**CALIFORNIA REGIONAL WATER QUALITY CONTROL BOARD
LAHONTAN REGION**

CLOSURE AND POST-CLOSURE WASTE DISCHARGE REQUIREMENTS FOR RESURGENCE SOLAR I, LLC AND RESURGENCE SOLAR II, LLC, SOLAR ELECTRIC GENERATING SYSTEMS III THROUGH VII, THREE SURFACE IMPOUNDMENTS, TWO LAND TREATMENT UNITS, AND POND NO. 5 LANDFILL

Response to Comments on Tentative Closure and Post Closure Waste Discharge Requirements for Solar Electric Generating Systems III-VII, Kramer Junction, San Bernardino County

Attachment C. Detail- Pond 5RSI-RSII Landfill Closure System

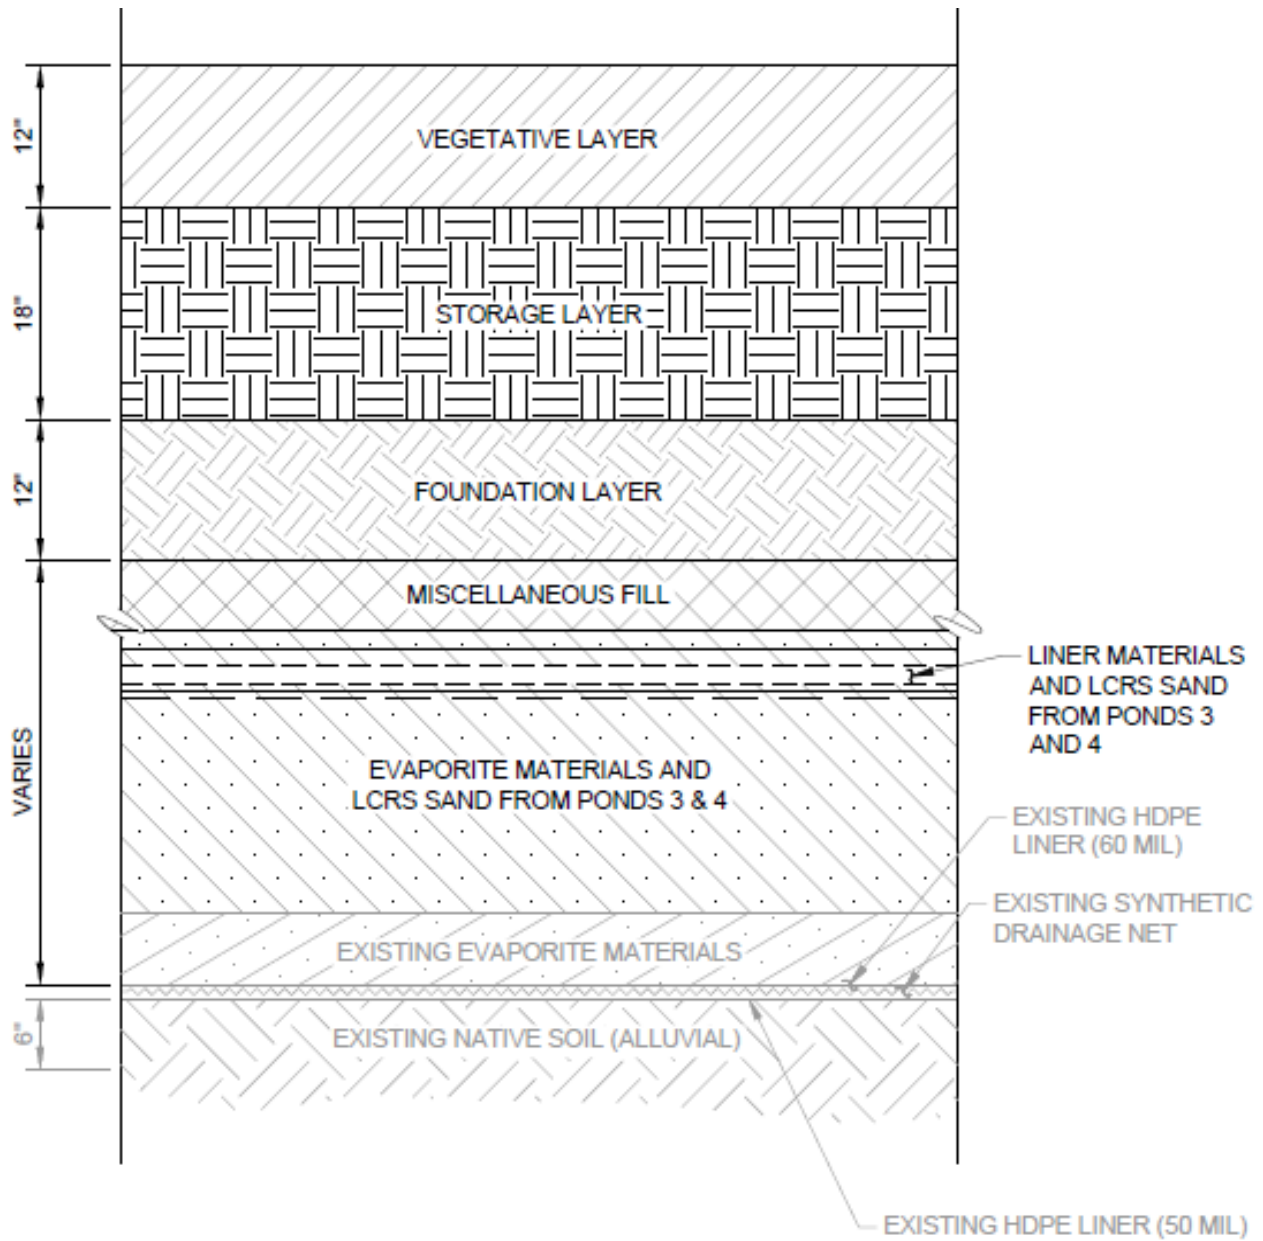
Comment 1 – WDR Finding 2 (page 2): Jeff Brooks confirmed via 11/22/22 e-mail that the liner materials (not the LCRS pipe) are acceptable for disposal in the Pond 5 LF if it is not feasible to recycle them. Recycling options were researched, and it was found to be infeasible; see Attachment 2 for the technical memo documenting the research. Due to sizing reduction and manageability issues with the liner material approximately 25% of it will be landfilled elsewhere. The remainder will be disposed in pond 5 LF. Revised attachment C cross section of LF (Attachment 3) was sent to Jeff Brooks at his request via e-mail on 11/15/22 modifying reference to LCRS materials.

Regional Board staff response: *The cross section has been updated from the previous draft based on the revised cross section received. This revised version will be part of the WDRs presented to the Regional Board for consideration for adoption.*
